Job No: P27338  
Name: Silva Cruz  
Address: Flat 4  
AA Louis Lane  
Tel: Swiss ODA  
Sheet:

P27338  
SILVA CRUZ

3 of 3

1 of 3

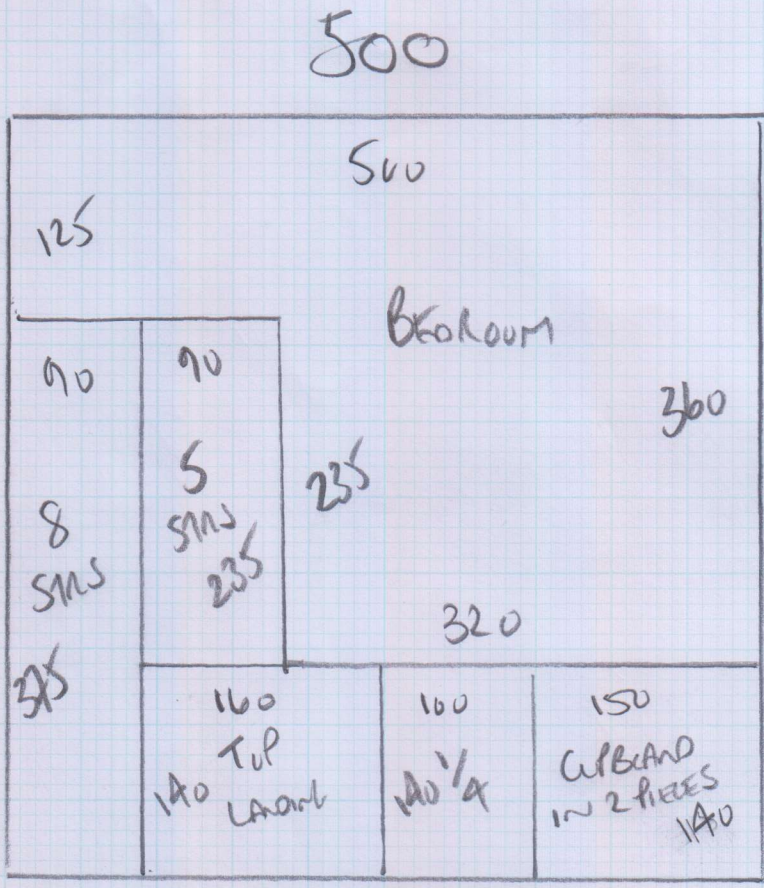
Stainless Twist  
STA-007

PLAN 500 x 500  
Lambe 400 x 500  
900mm x 500mm

45m<sup>2</sup>

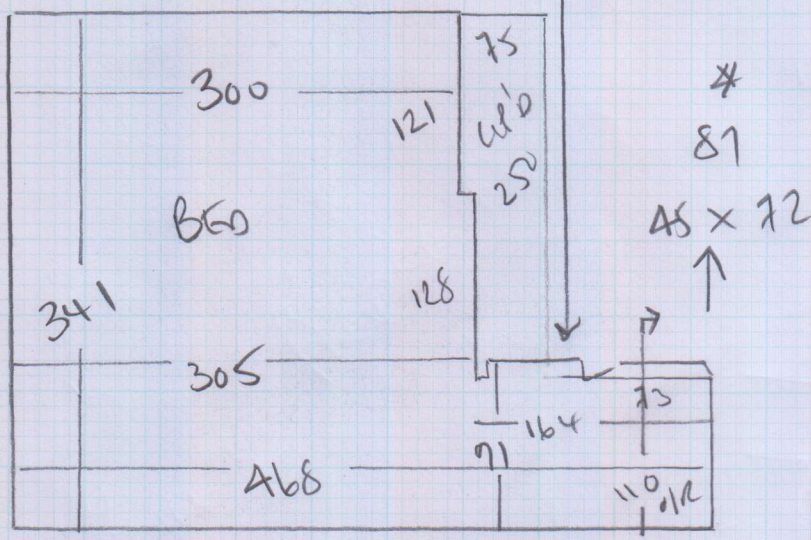
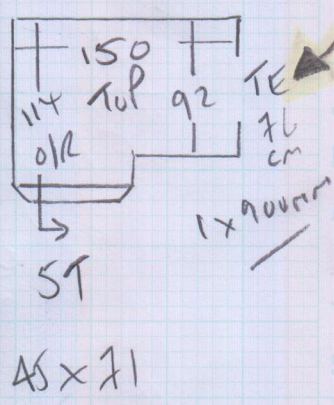
Bathroom Tiles  
 20mm - 3mm HEIGHT  
 FROM LEFT TO RIGHT  
 (VARY BY 10mm)  
 LEVELS DIFFER

FIT SKIN + BAR AS BEST POSSIBLE

\*  
 Fit S/NAP (38cm)  
 TO THIS EDGE  
 - Riser + Nose To Be  
 PAINTED

A 12mm easy shim ramp will be required to raise the height of the carpet to meet the ceramic tile height in the bathroom, However the tile height is 20mm on one side and 30mm on the other(not level) so some of the easy shim will need to be cut away on the left hand side to achieve the correct finish

As you can see from the photograph the left hand side of the tiled doorway will not require the easy shim profile so it will need to be cut to suit on site at this juncture

It was agreed during our site survey that a single naplock profile should be installed to the side of the small landing as this will provide the most aesthetically pleasing finish as the carpet is not able to go over the front of the riser as well as the side!

It was agreed that the side of this step will be painted and made good prior to our arrival

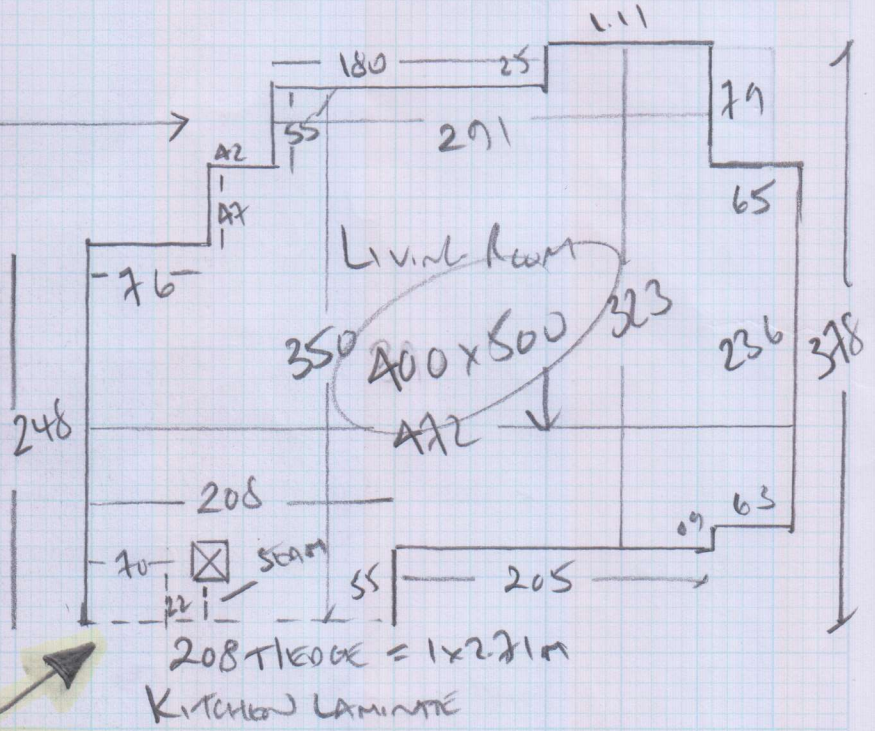
LAM OVER EXISTING  
 FIRE BOARD SOUND PROOFING  
 5mm THICK

CUT BACK FIREBOARD AT JUNCTION  
 WITH LAMINATE SO TILE EDGE BAR  
 SITS PROPERLY

\* BILLY - PLEASE READ!

The fibre board sound proofing will need to be cut away by approximately 3cm to facilitate the installation of the tile edge doorbar that has been specified to be installed between the reception room carpet and the kitchen laminate flooring
